**LOUISIANA**  
**POWER & LIGHT**

August 19, 1981  
W3P81-1835  
3-A19.09

SUBJECT: Waterford 3 SES  
TMI Item II.E.4.2 - Containment  
Purge Valve Operability Study

Attachment 3 - Capacity and Dynamic Torque  
Curves Determined in Fis'ore  
Lab. Tests for 6" Type 9240  
Butterfly Valve.

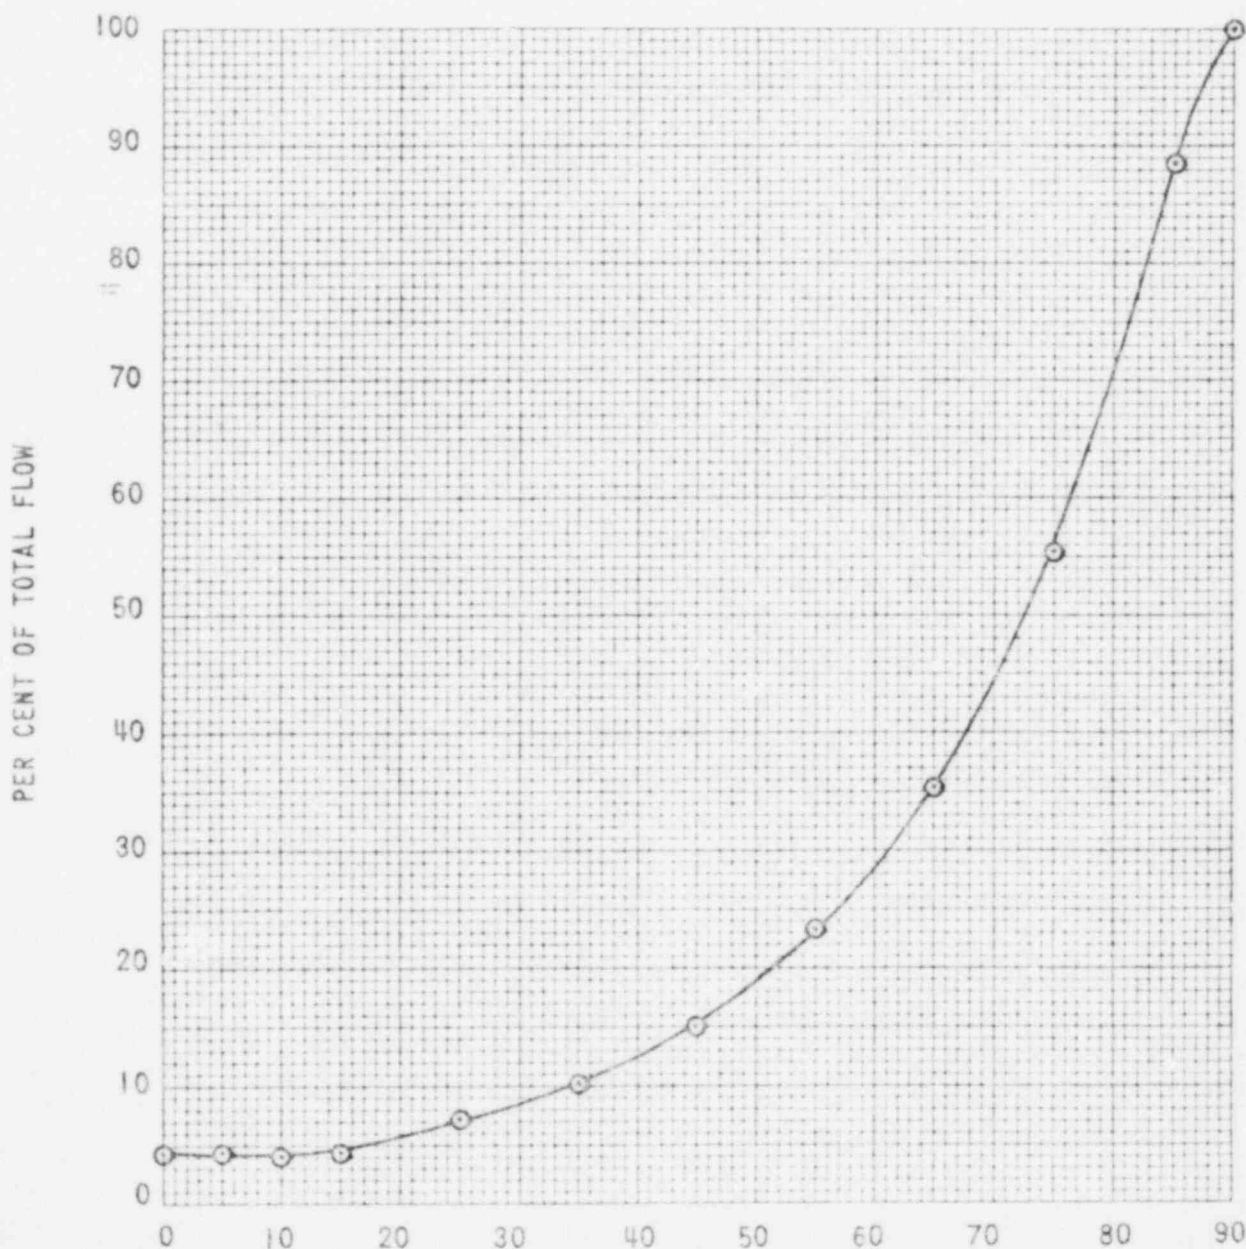
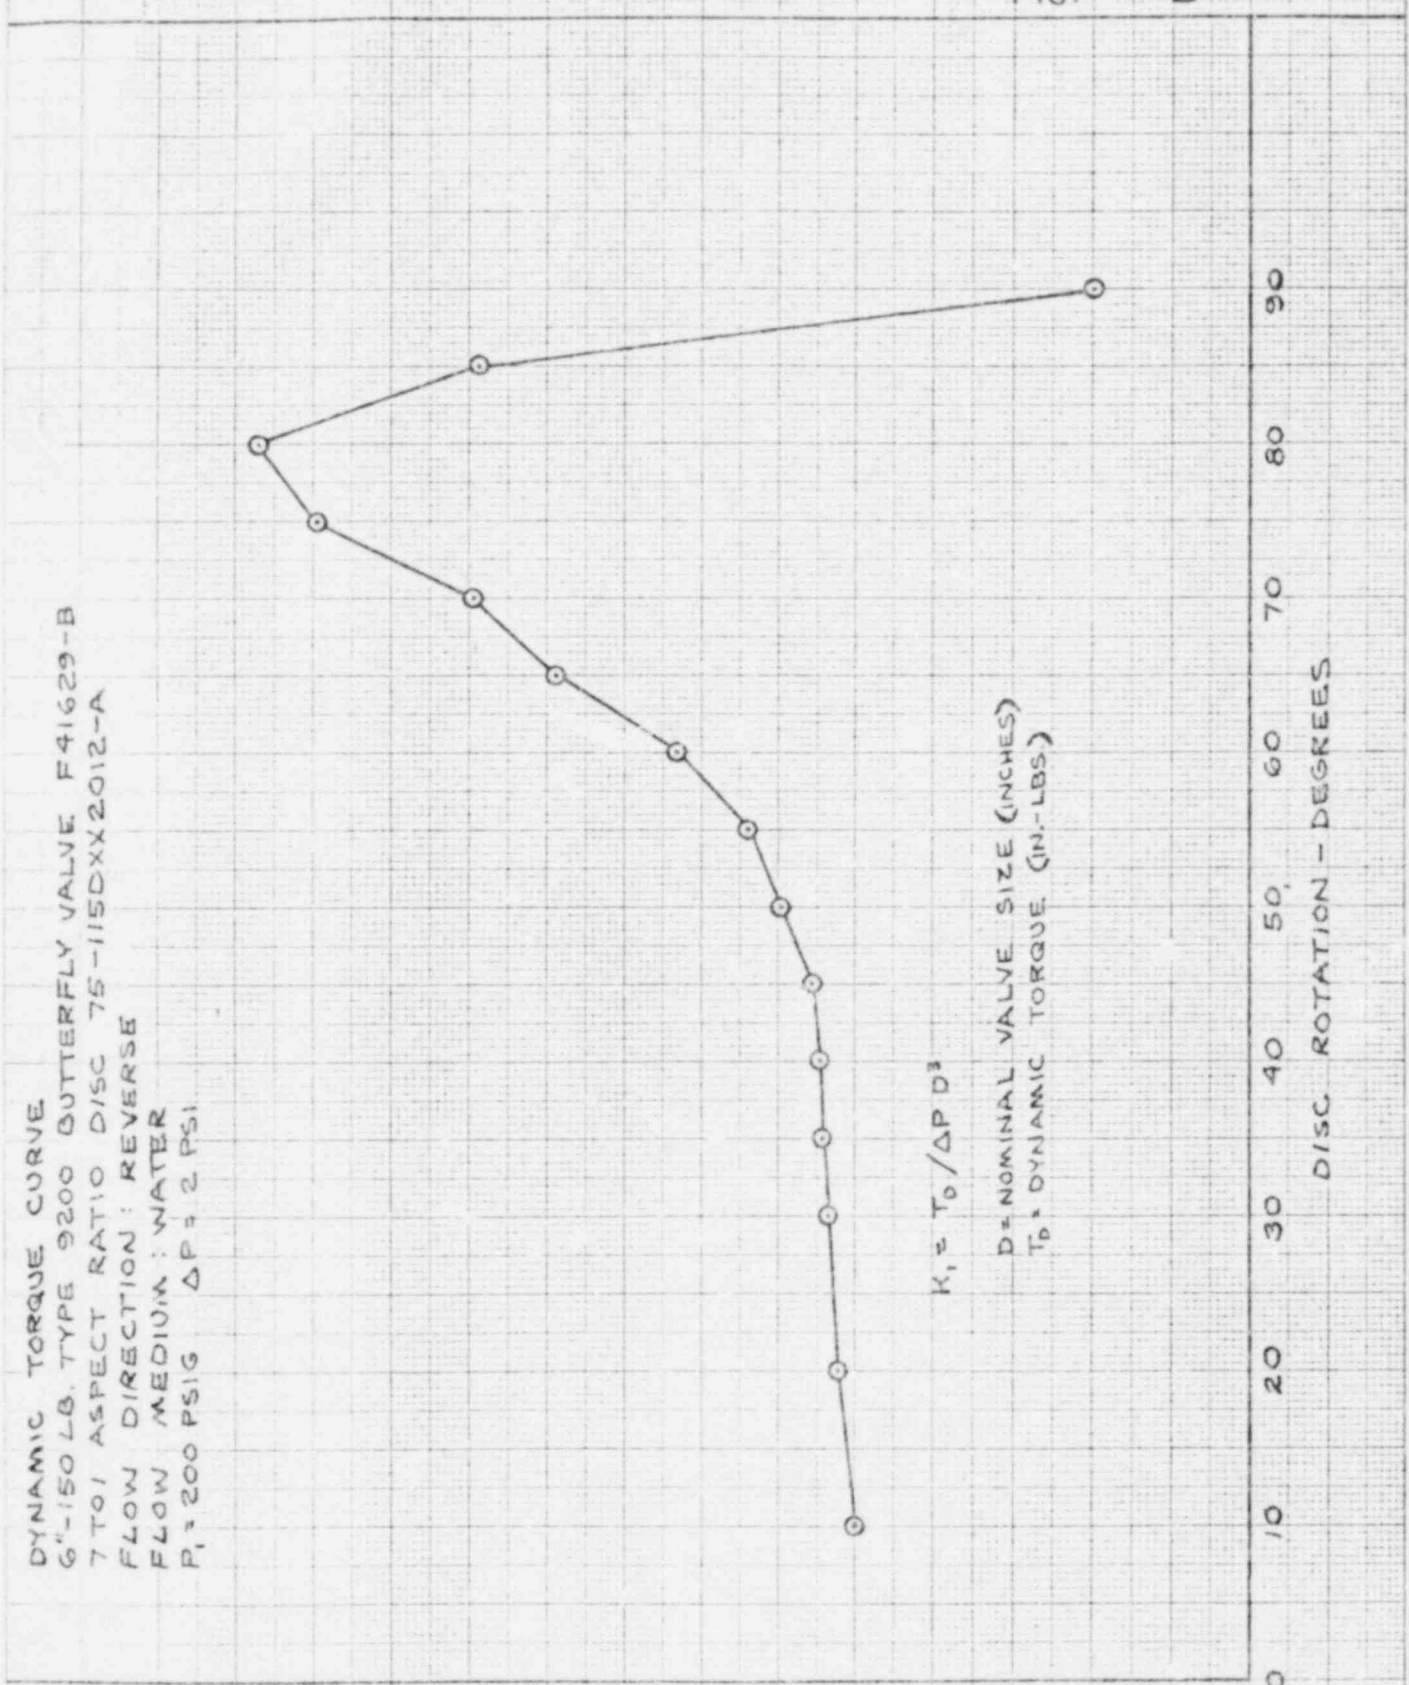
Were the dynamic torque coefficients used for the determination of torques developed based on data resulting from actual flow tests conducted on the particular disc shape/design/size? What was the basis used to predict torques developed in valve sizes different (especially larger valves) than the sizes known to have undergone flow tests?

The model tests used to establish the dynamic torque values used in sizing were conducted using 4" and 6" test valves with various aspect ratios ranging from 2:1 to 14:1 (such as 3:1, 4:1, 5:1, 8:1, 11:1 and 14:1). The dimensionless aspect ratio (defined as the ratio of the disc diameter to the hub diameter) was judged to be a significant parameter for evaluation of dynamic torques at various open angles.

Capacity and Torque curves obtained from a typical test are enclosed (Attachment 3) to illustrate the method and general shape of the curves for type 9200 butterfly valves.
